### **PLANNING & ZONING COMMISSION SPECIAL MEETING**

**THURSDAY, MARCH 10, 2022 - 3:30 PM**

## SUBDIVISION PLAT REVIEW

| <b>SUBDIVISION NAME: SUAREZ SUBDIVISION</b>   |                |

SUBDIVISION PLAT OF  
SUAREZ SUBDIVISION

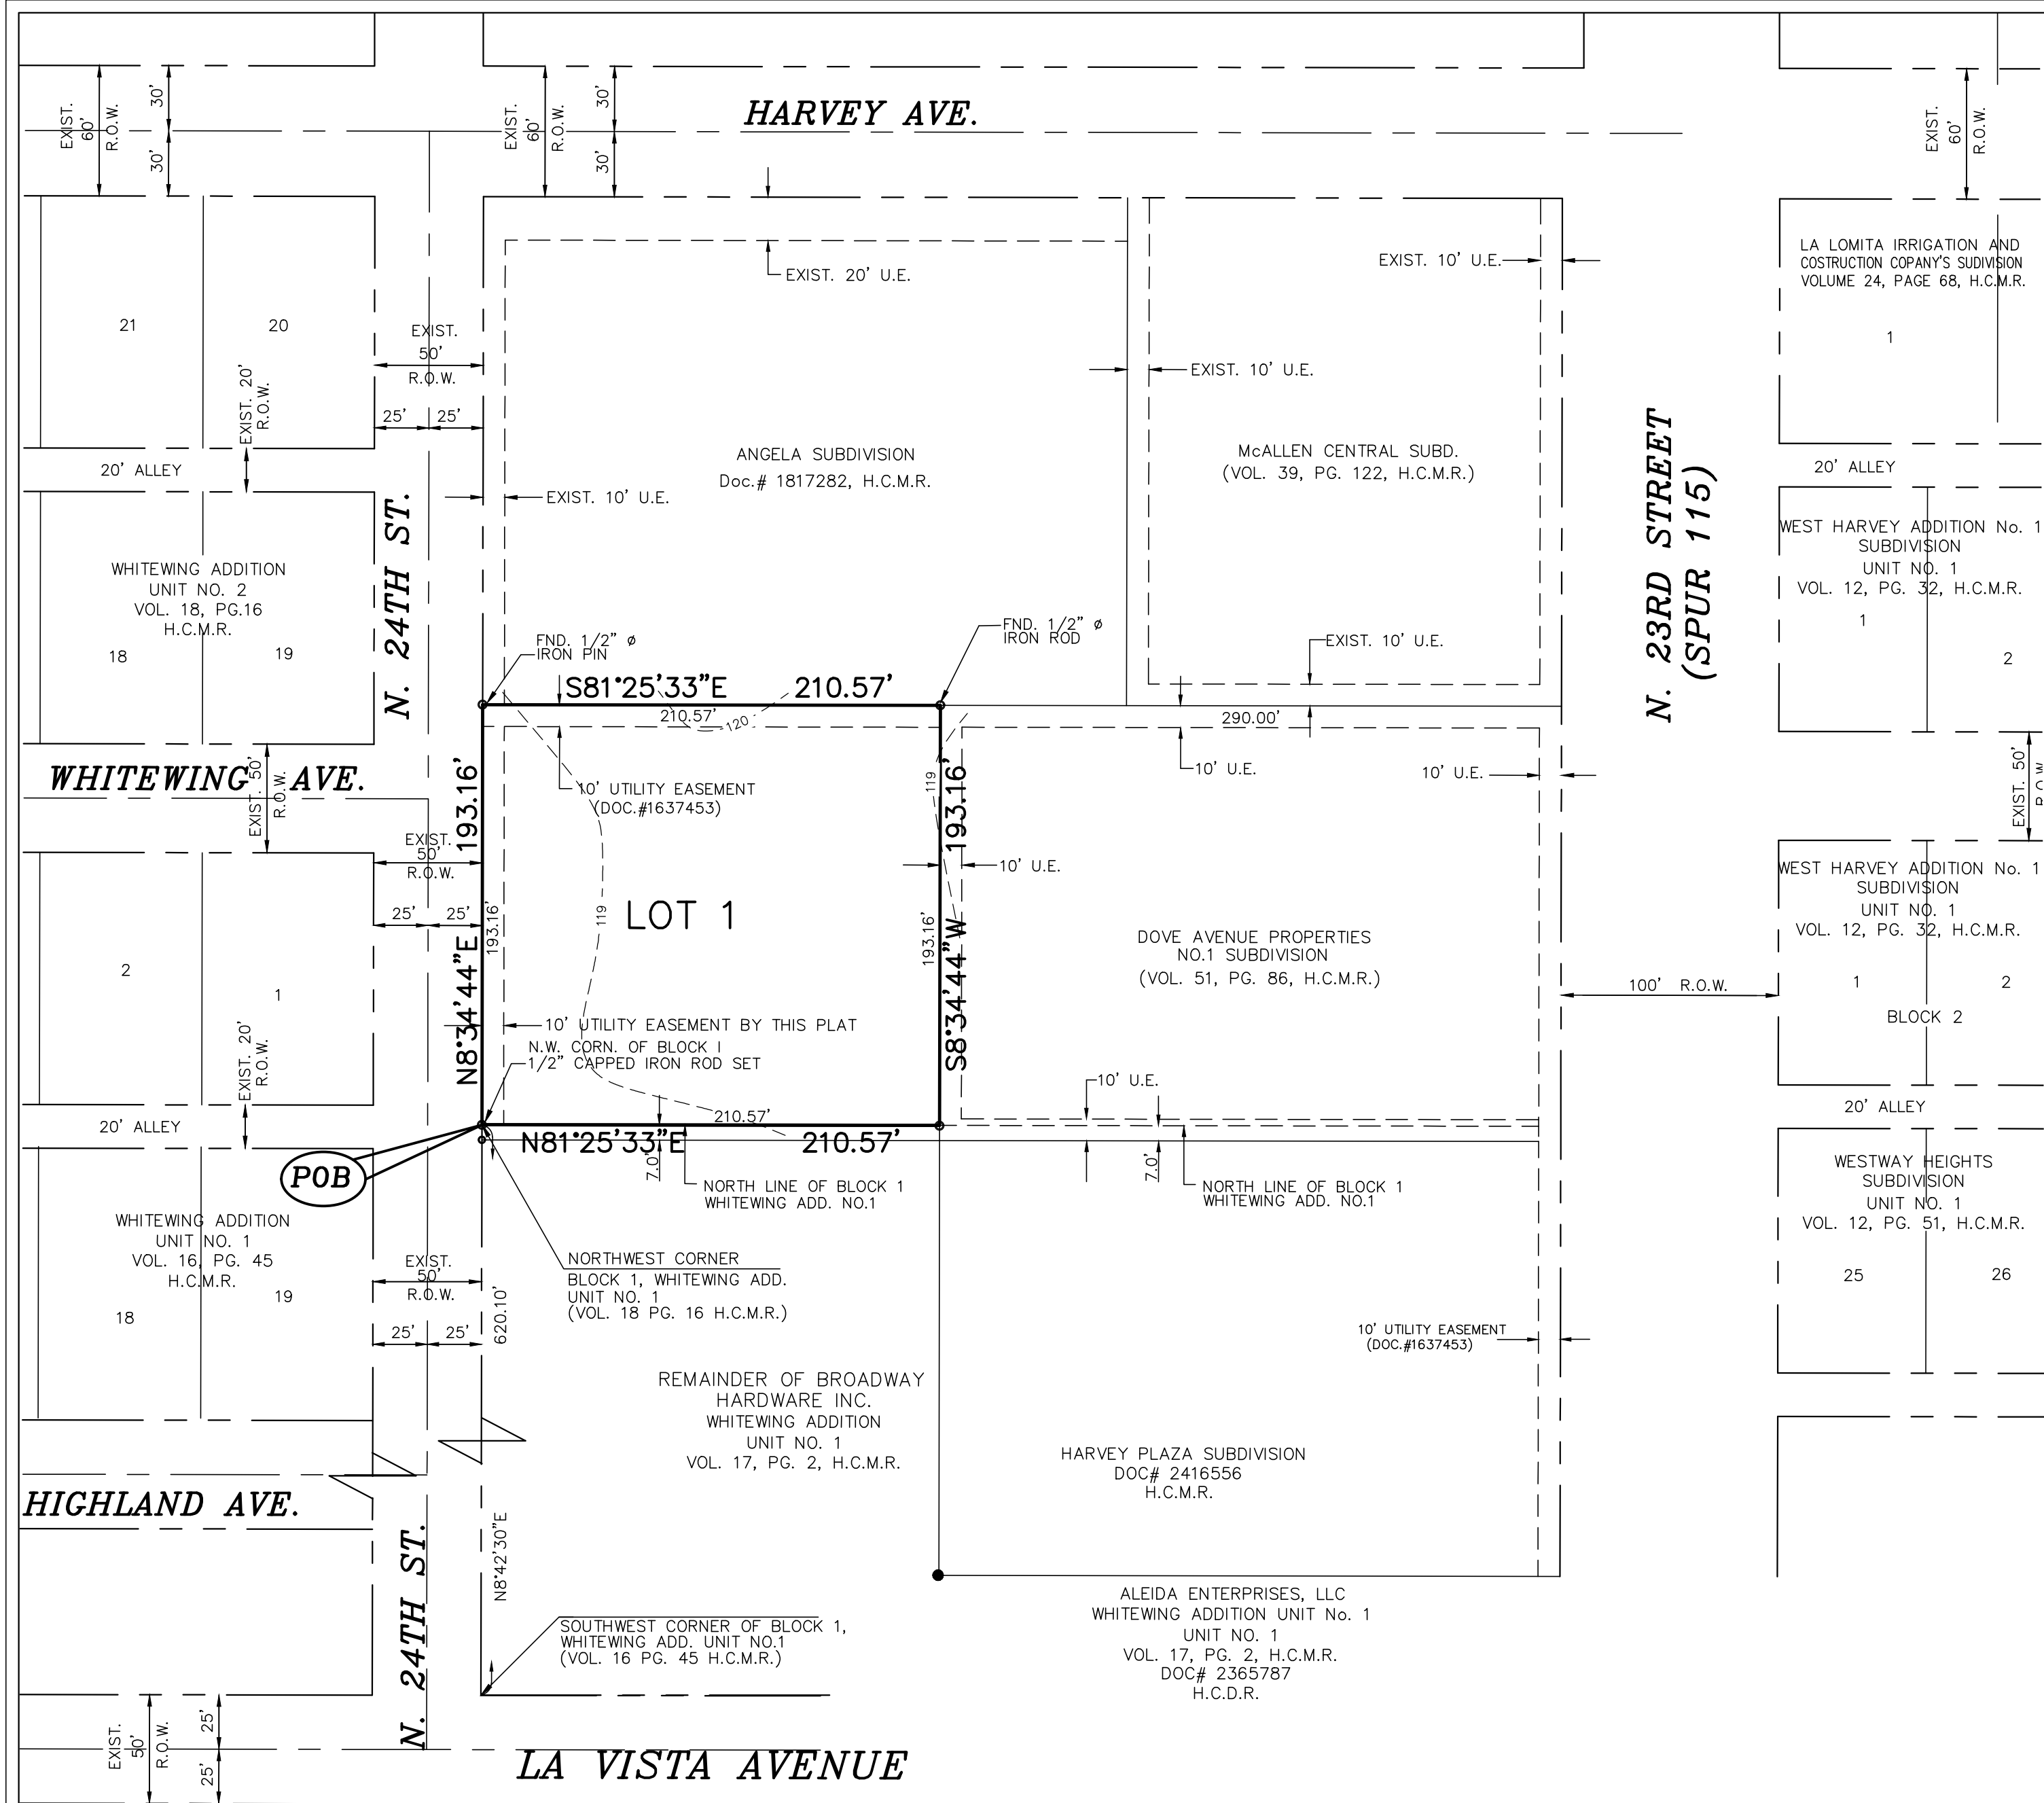
| <b>SUBDIVISION NAME: SUAREZ SUBDIVISION</b>   |                |
|---|----------------|
| N. 24th Street: 25 ft. from centerline for 50 ft. total ROW<br>Paving: 32 ft. Curb & gutter: Both Sides<br>**Please clarify how 25 ft. from centerline was dedicated on plat and include document numbers as needed prior to final.<br>**Subdivision Ordinance: Section 134-105<br>**Monies must be escrowed if improvements are required prior to final<br>**COM Thoroughfare Plan | Non-compliance |
| ROW: 20 ft. Paving: 16 ft.<br>*Alley/service drive easement required for commercial properties<br>**Subdivision Ordinance: Section 134-106  | Non-compliance |
| * Front: In accordance with zoning ordinance, or greater for easements or approved site plan, or in line with average setback, whichever is greater.<br>**Revise plat note #3 as shown above prior to final.<br>**Zoning Ordinance: Section 138-356   | Non-compliance |
| * Rear: In accordance with zoning ordinance, or greater for easements or approved site plan.<br>**Revise plat note #3 as shown above prior to final.<br>**Zoning Ordinance: Section 138-356   | Non-compliance |
| * Sides: In accordance with zoning ordinance, or greater for easements or approved site plan.<br>**Revise plat note #3 as shown above prior to final.<br>**Zoning Ordinance: Section 138-356  | Non-compliance |

| SIDEWALKS   |                |
|---|----------------|
| * 6 ft. opaque buffer required from adjacent/between multi-family residential and commercial, and industrial zones/uses, and along N. 24th Street.<br>**Buffer requirement on N. 24th Street will be finalized prior to final<br>**Please revise plat note #8 as shown above once finalized prior to final<br>**Landscaping Ordinance: Section 110-46   | Non-compliance |
| * 8 ft. masonry wall required between single family residential and commercial, industrial, or multi-family residential zones/uses.<br>**Please add plat note as shown above prior to final<br>**Landscaping Ordinance: Section 110-46  | Non-compliance |

| * Existing: R-3T Proposed: C-3<br>**Rezoning will be required prior to final<br>***Zoning Ordinance: Article V  | Non-compliance |
| * As per Traffic Department, Trip Generation required to determine if TIA is required, prior to final plat.   | Non-compliance |
